## **Monolith Well Permit Application**

**Submitted to the Lower Platte South Natural  
Resources District**

June 4, 2021

**FIGURE 1  
ACTIVE GRID  
AND WELL LOCATION**

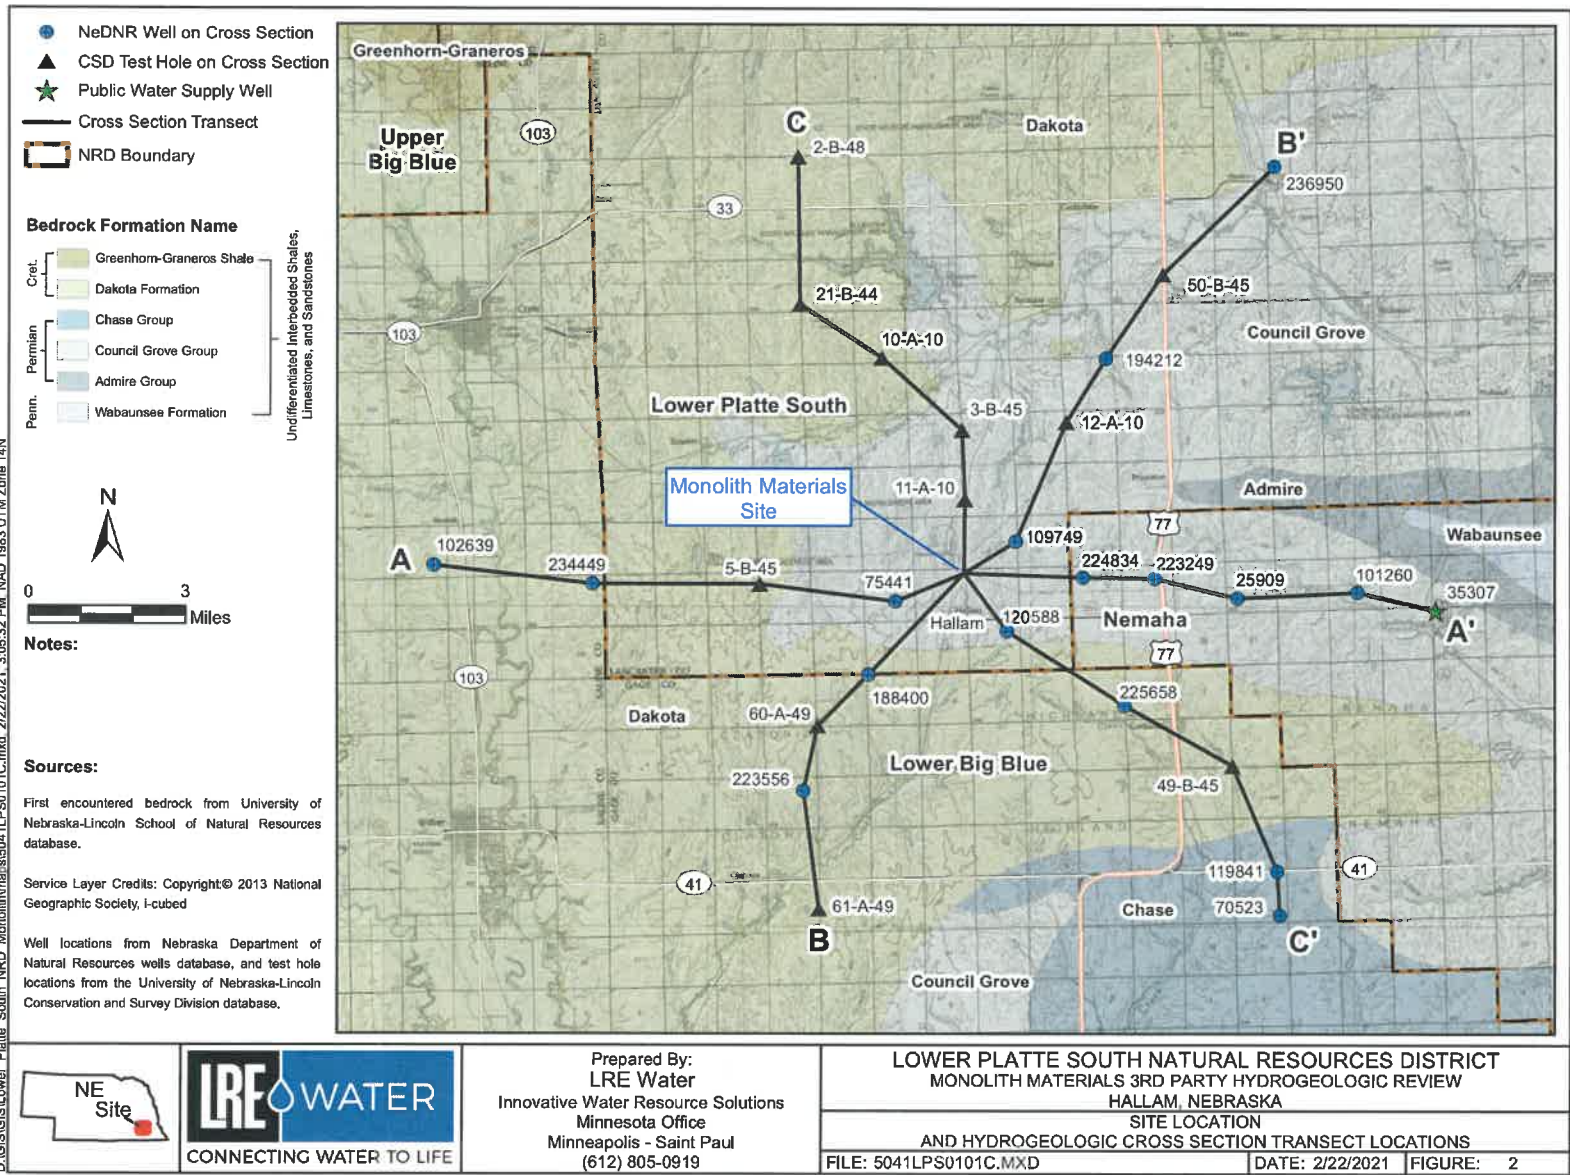
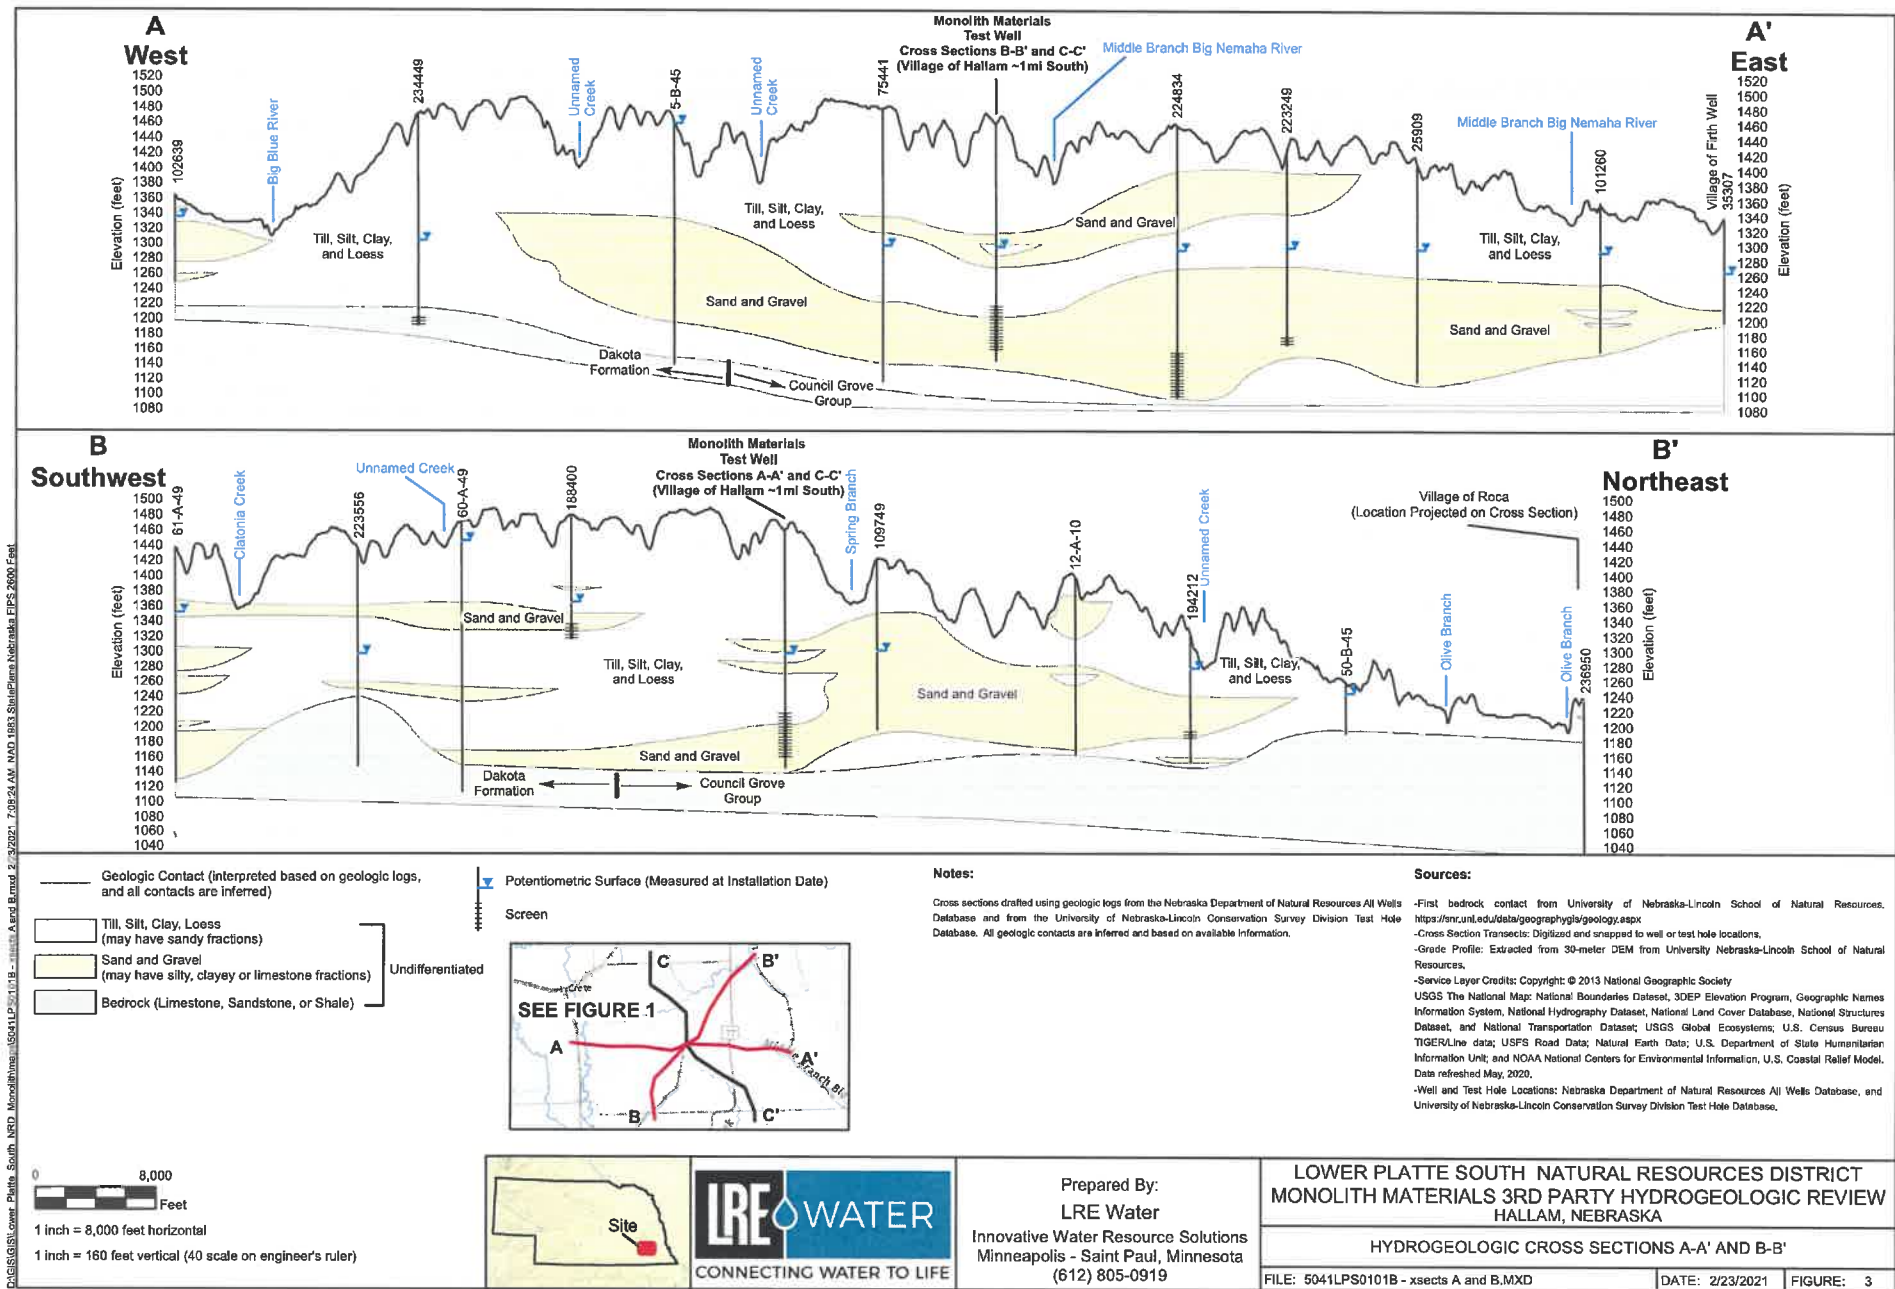
The extent and spatial discretization of the Model is shown on **Figure 1**. The projected geographic coordinate system utilized is State Plane Nebraska FIPS 2600. The units are in feet (ft). The southeast corner of the model is located at 245520 ft Northing and 2477635 ft Easting. The spatial discretization is variable and ranges from 165 ft square to 2640 ft square. The smallest discretization surrounds the streams and the Monolith Well on the Site.

FIGURE: 4

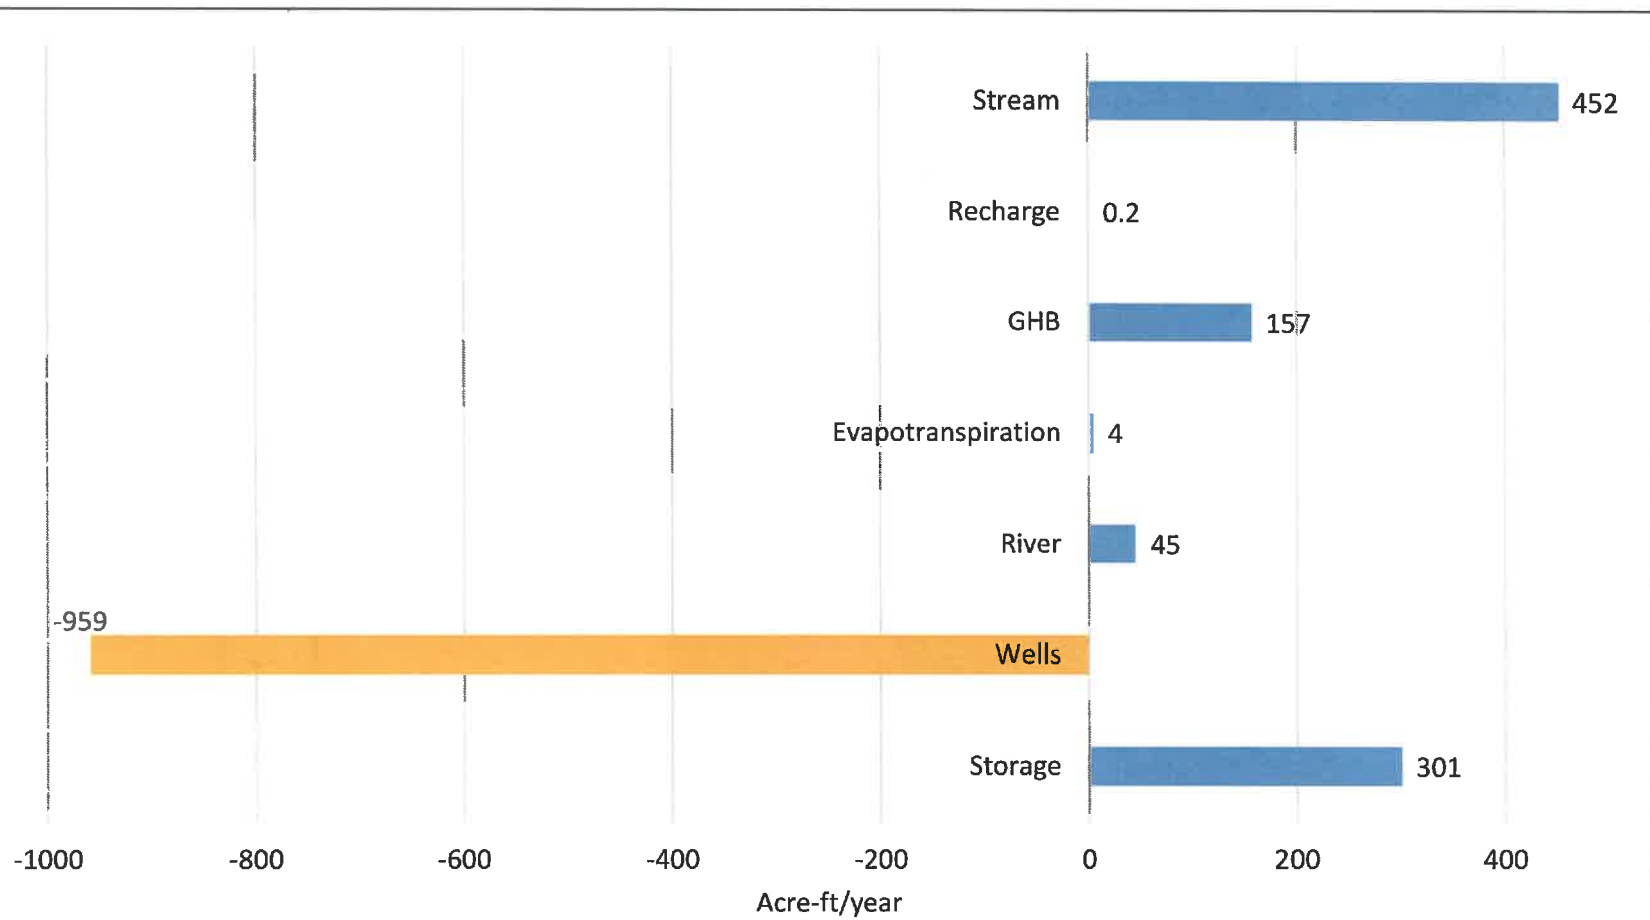
To assist in our evaluation of the conceptual hydrogeology of the Model domain, LRE constructed three hydrogeologic cross sections through the locations shown on **Figure 2**. The cross sections are referenced at A-A', B-B', and C-C' and are shown on **Figures 3 and 4**. Based on our review of geologic information, including borehole logs, the cross sections, and peer reviewed publications, it is our opinion that the structure of the CPA aquifer represented in the Model represents the known geology adequately.

**Figure 5**  
**Cumulative Water Budget Difference For**  
**Pumping and Non-Pumping Scenarios**  
**(acre-ft/year)**

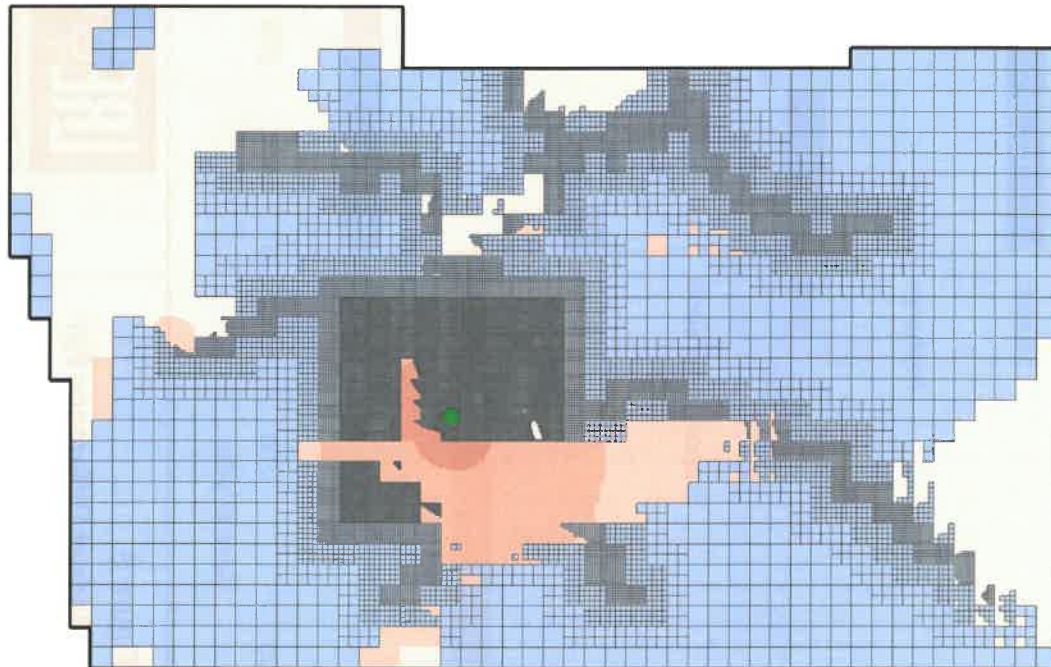
Another main object of the Model is to simulate the effect of pumping on surface streams. To review this, we compared the modeled water budget for the Monolith pumping and no-Monolith-pumping scenarios. The model budget difference highlights the source of water to the Monolith Well. The differences from pumping can be seen in **Figure 5** and **Table 1**. The surface water contributions (River and Streams) account for 52% of the water pumped from the Monolith Well over 50 years. Water coming from aquifer storage accounts for 31%. The remaining significant portion (16%) comes from the General Head Boundaries from the North, South, and East. Our results are identical to the results presented by the Model. The predicted reduction in stream flow of 452 acre-feet per year is equivalent to a reduction of approximately 0.6 cubic feet per second (cfs). The impact to the GHB Boundaries of 157 acre-feet per year is equal to an additional 0.2 cfs which is likely to manifest as a reduction in outflow to streams outside of the model domain. Together, these comprise a total predicted stream flow reduction of approximately 0.8 cfs.

**FIGURE 6**  
**DRAWDOWN IN**  
**LAYER 1 AFTER**  
**50 YEARS PUMPING**

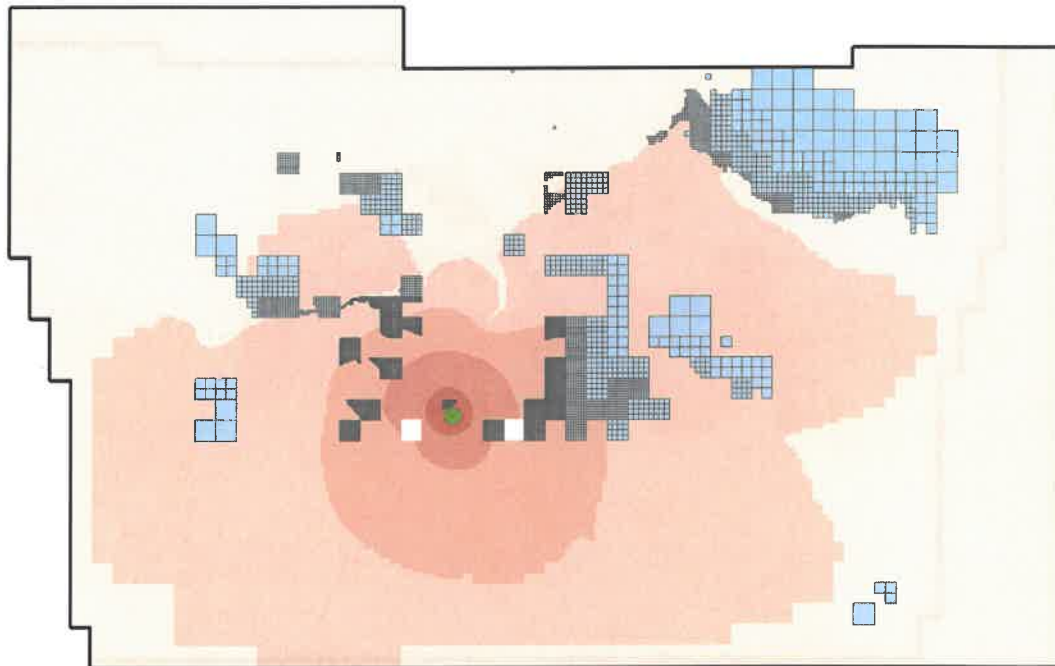
A water table drawdown map was created for each layer in the Model, comparing the final time step at the end of 50 years (**Figures 6-9**). The drawdown in all layers (**Figure 10**) was used to create a full drawdown map. Comparing these results to figure 3.14 in the Olsson (2020), (**Appendix A**) we find that they are very similar, but not exactly the same. The first difference is that Appendix A shows the contour interval with a maximum decline of -0.1 feet, but it is not shown. The second is that the maximum drawdown in all layers on the final time step of the Model is 6.9 feet near the Monolith Well. **Appendix A** shows contours up to -8.5 feet and that amount of drawdown is referenced in the Discussion section of the Olsson (2020). Lastly some of the contour intervals are slightly different from each other. These differences in **Figure 10** and **Appendix A** do not change our opinion on the overall Model. We suspect that the minor differences we encountered are due to differences in initial heads, contouring methods, or the exact time used for the drawdown analysis. These minor differences do not affect the overall conclusions of our analysis, however, we recommend providing a model addendum to document exactly how Olsson's drawdown maps were developed.
